ARKANSAS POWER & LIGHT COMPANY  
POST OFFICE BOX 551 LITTLE ROCK, ARKANSAS 72203 (501) 371-4000

November 12, 1982

1CAN118203

SUBJECT: Arkansas Nuclear One - Unit 1  
Docket No. 50-313  
License No. DPR-51  
Inservice Inspection (ISI)  
Relief Requests

Figure 1 to  
1CAN118203

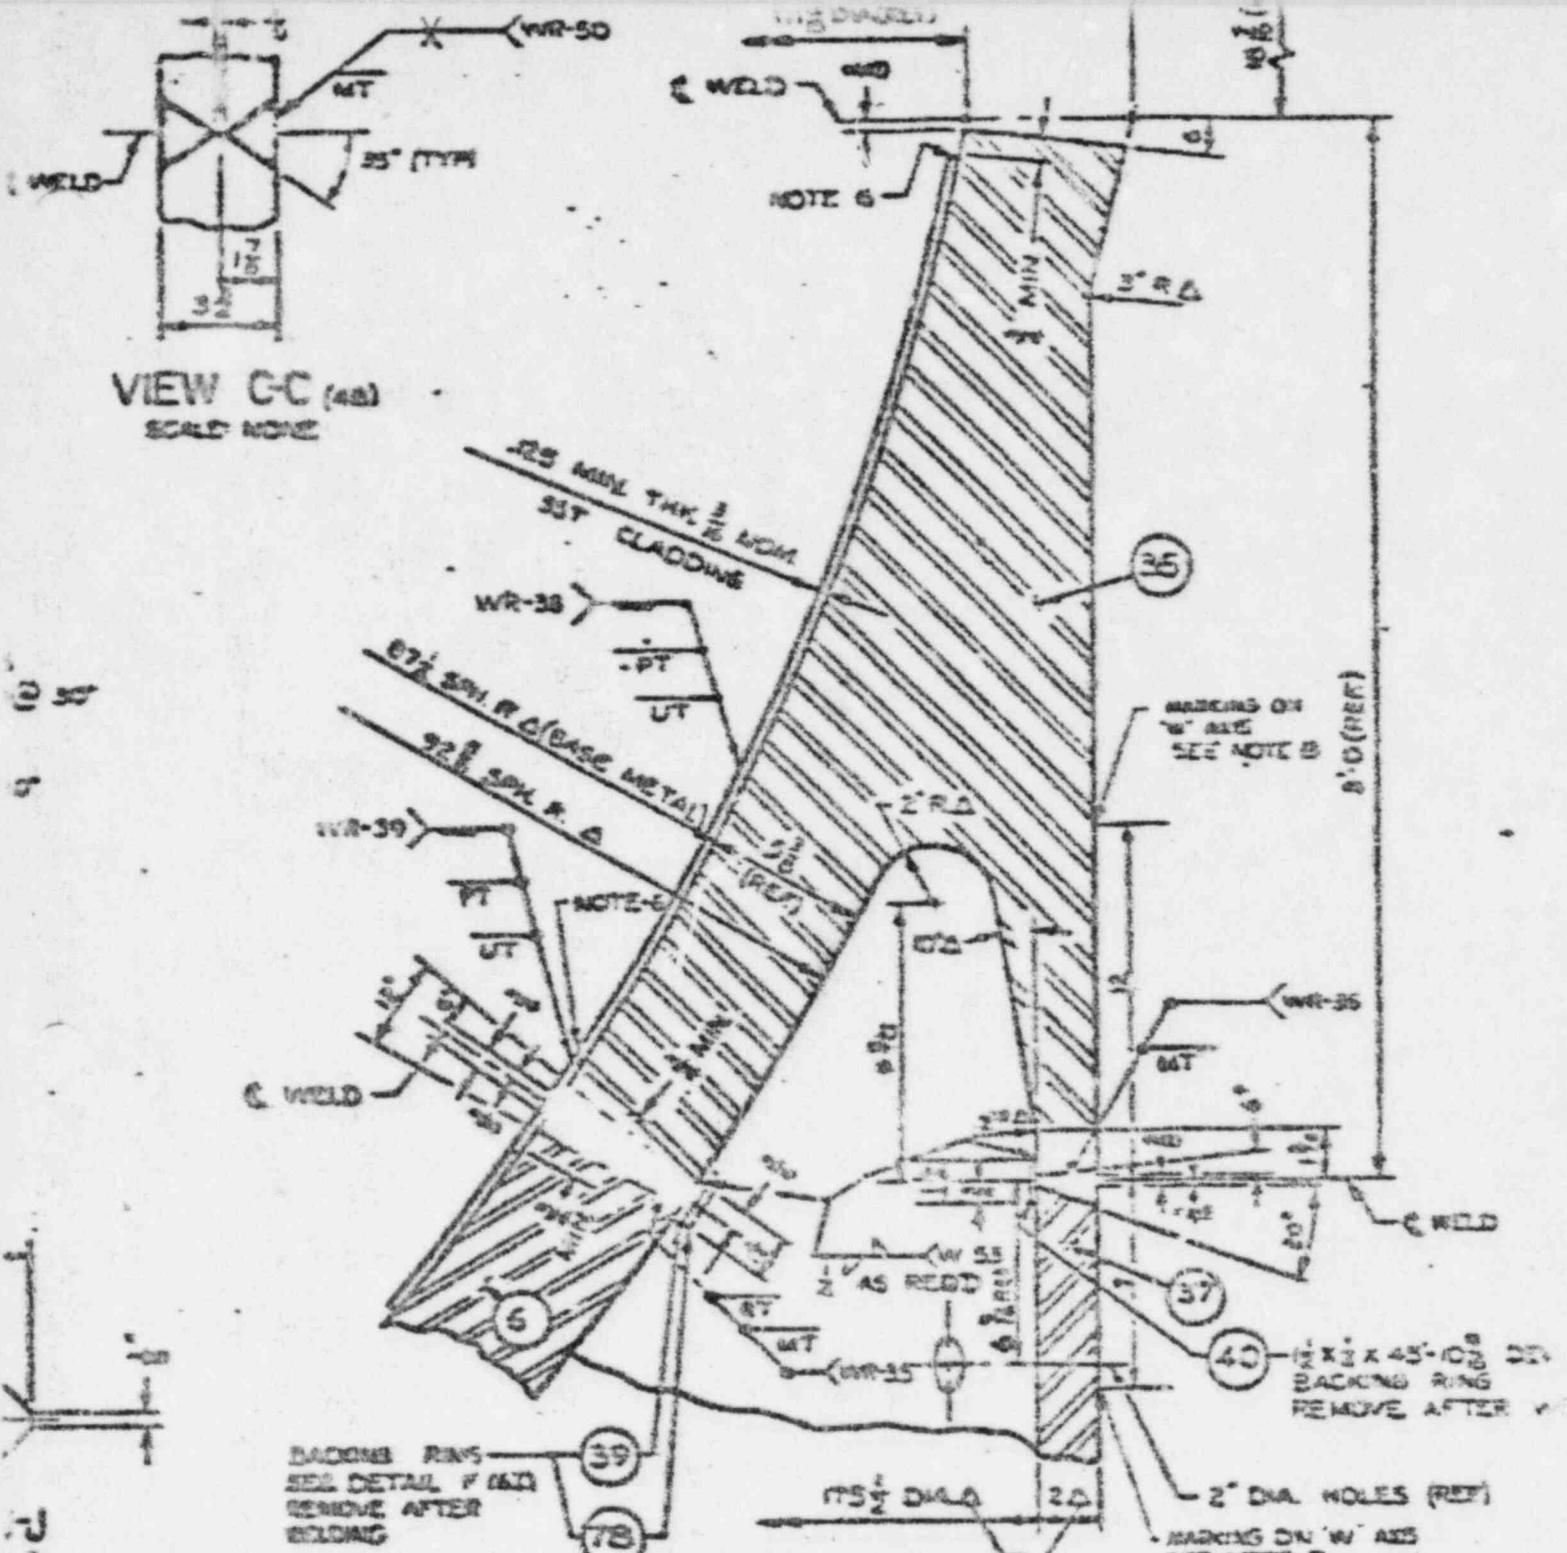
- (2) AP&L requests relief from the requirement to do a volumetric examination of the reactor vessel support skirt weld as required by the 1974 Edition of Section XI (Item B1.12, Examination Category B-H).

Basis - The reactor vessel support skirt-to-vessel weld is impractical to examine volumetrically considering access for examination equipment, the necessity of insulation removal, personnel exposure to a 150-200 mR general area radiation field in the range of 1R on contact with insulation, and the amount of time required to obtain acceptable results. With insulation removed, close proximity radiation readings are expected to be considerably higher. This weld is not considered part of the Section XI, Class 1 (IWB) boundary under the rules of the 1980 Edition and therefore would be exempt from any examination requirements (See Figures 1 & 2).

Proposed Alternate Examination - None.
